United States Patent and Trademark Office

APPLICATION NO.	FILING DATE	FIRST NAMED INVENTOR	ATTORNEY DOCKET NO.	CONFIRMATION NO.	
10/809,934	03/26/2004	Akira Yamamoto	59558.00023	6428	
32294 75	90 11/17/2006		EXAM	EXAMINER	
SQUIRE, SANDERS & DEMPSEY L.L.P.			JIMENEZ, MAI	JIMENEZ, MARC QUEMUEL	
14TH FLOOR 8000 TOWERS CRESCENT		ART UNIT	PAPER NUMBER		
	TYSONS CORNER, VA 22182			3726	
			DATE MAILED: 11/17/200	DATE MAILED: 11/17/2006

Application No.	Applicant(s)				
Office A - 4' Occasional	10/809,934	YAMAMOTO ET AL.				
Office Action Summary	Examiner	Art Unit				
	Marc Jimenez	3726				
The MAILING DATE of this communication appears on the cover sheet with the correspondence address Period for Reply						
A SHORTENED STATUTORY PERIOD FOR REPLY IS SET TO EXPIRE 3 MONTH(S) OR THIRTY (30) DAYS, WHICHEVER IS LONGER, FROM THE MAILING DATE OF THIS COMMUNICATION. - Extensions of time may be available under the provisions of 37 CFR 1.136(a). In no event, however, may a reply be timely filed after SIX (6) MONTHS from the mailing date of this communication. - If NO period for reply is specified above, the maximum statutory period will apply and will expire SIX (6) MONTHS from the mailing date

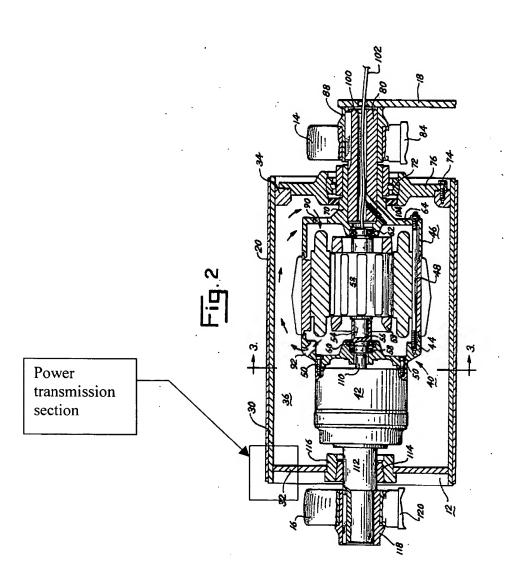
Chung teaches a motorized roller comprising: a roller body 20,30 of the motorized roller; a motor 46 disposed inside the roller body 20,30; a reducer 40 which is disposed inside the roller body 20,30, and reduces the rotation of the motor 46; and a rotor 112 which is disposed inside the roller body 20,30, and connected with the reducer 40 and the roller body 20,30 to transmit power of the reducer 40 to the roller body 20,30; wherein the roller body 20,30

comprises a first roller body 20 and a second roller body 30, and the first roller body 20 and the second roller body 30 is connected at a power transmission section (above reference numeral 32 in figure 2) between the rotor 112 and the roller body 20,30. See mark-up of figure 2 below for what is considered a "power transmission section", similar to figure 3(A) of the instant invention where reference character "x" defines a "power transmission section".
